**ADDENDUM NO. 3
TO THE
SPECIFICATIONS, PROPOSAL, AND CONTRACT DOCUMENTS**

**TOTEM LAKE CONNECTOR BRIDGE
JOB # 01-20-PW/NMC0861000**

CITY OF KIRKLAND, WASHINGTON

ITEM NO. 3: Revised Plan Sheets

CITY OF KIRKLAND
TOTEM LAKE PEDESTRIAN BRIDGE
DEMOLITION AND EROSION CONTROL PLAN 7

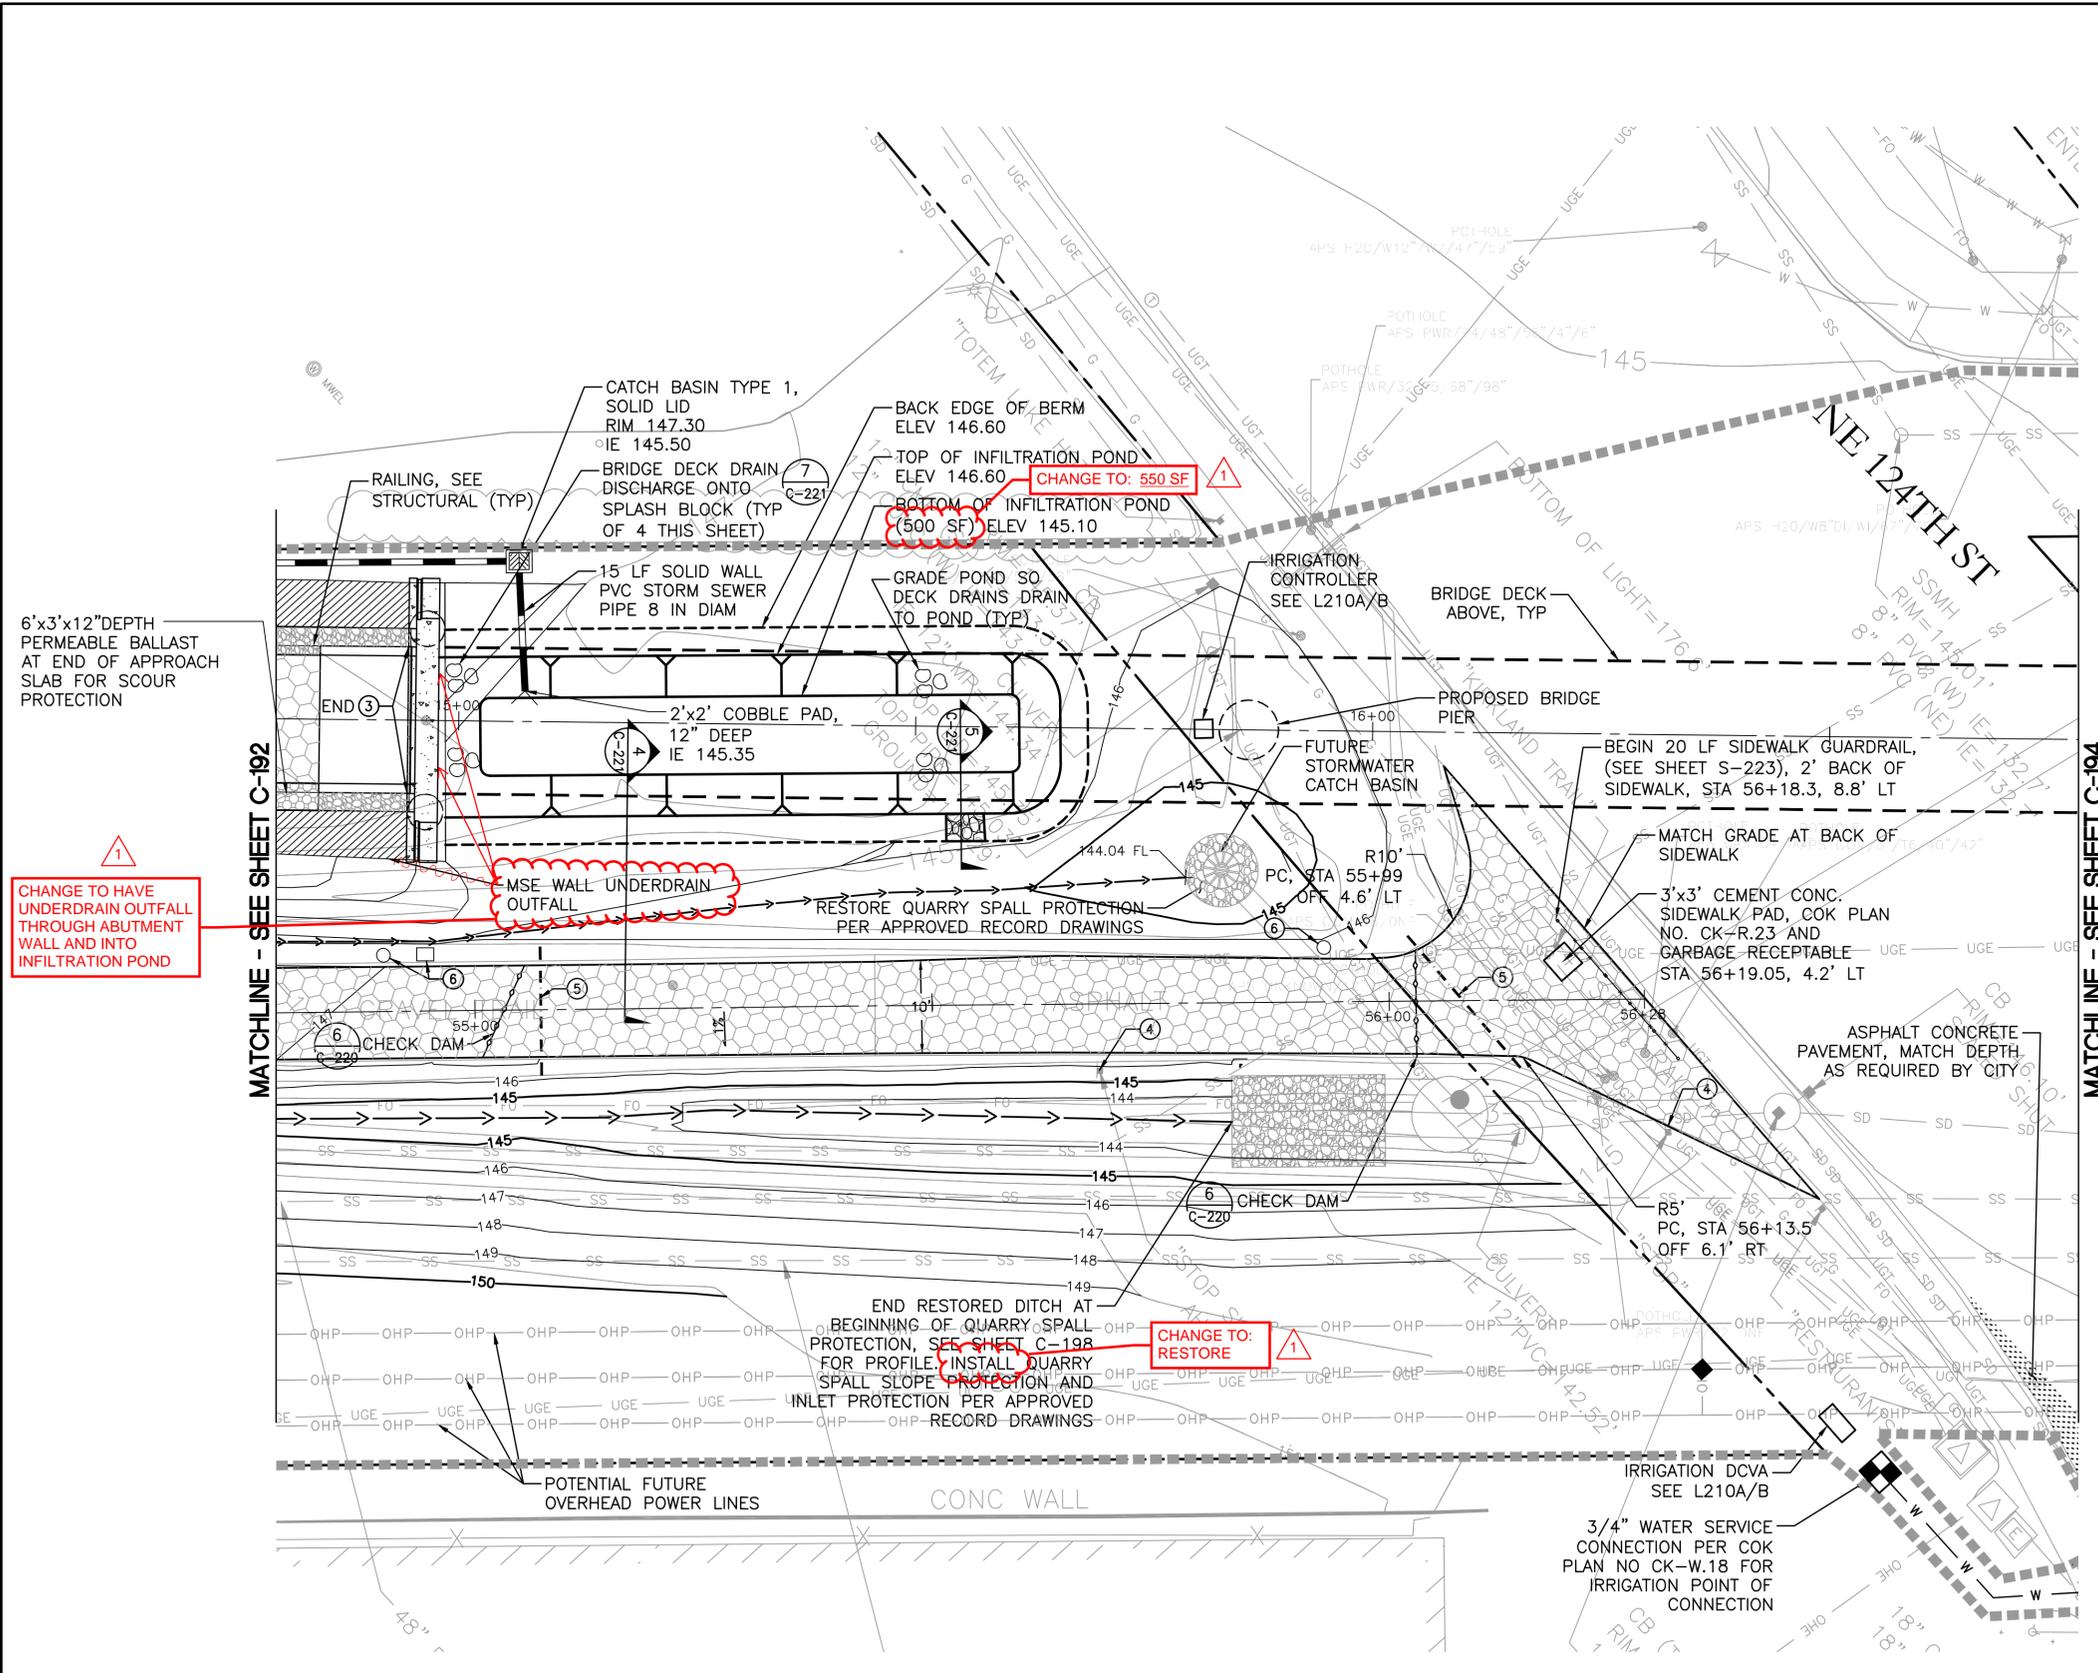
Revise General Note 7 to read:
"SEE SPECIAL PROVISIONS FOR HANDLING, TESTING, CHARACTERIZATION, AND DISPOSAL OF IMPACTED SOILS."
